Architectural Review Board Report

Architectural Review Board Meeting: October 19, 2020

To: Architectural Review Board
From: Gina Szilak, Associate Planner
CC: Stephanie Reich, AIA, LEED AP, Design and Historic Preservation Planner
Subject: 20ARB-0205 to approve the design, colors, materials, and landscape plans for the construction of a new two-story, approximately 32 feet high, 2,975 square-foot mixed use project comprised of one residential dwelling unit and 4 parking spaces located on an irregular lot within the GC (General Commercial) District.

Address: 3280 Lincoln Boulevard
Applicant: John Hamilton, AIA

Existing Site Plan

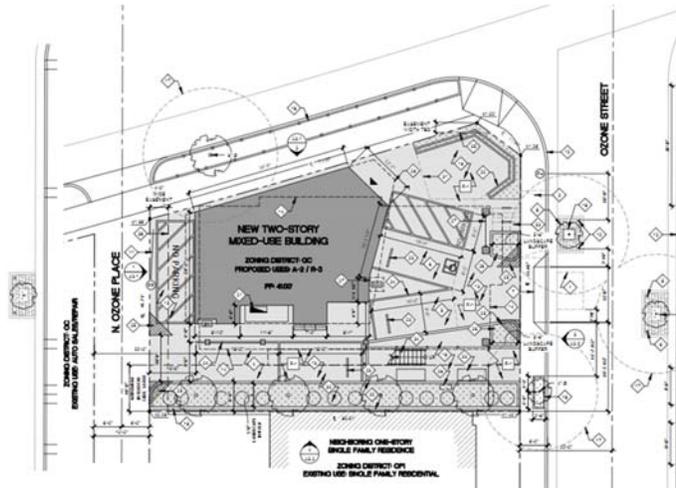
The project site consolidates two adjoining lots within an irregularly shaped lot fronting Lincoln Boulevard, Ozone Street and a substandard 12-wide alley along Ozone Place North. The proposed project is comprised of a two-story detached building with a single residential upper level unit and ground floor commercial space fronting Lincoln Boulevard. Access to the lot posed challenges constrained by the alley narrowness, heavy traffic along Lincoln Boulevard and the barriers designed within the Ozone “living street” which contained ballads and landscape typically located within the street public street right-of-way. Thus, the solution includes commercial automobile access from Ozone Street accomplished by relocating the existing Ozone curb cut and street tree and two tandem residential parking spaces accessed from Ozone Place North alley.
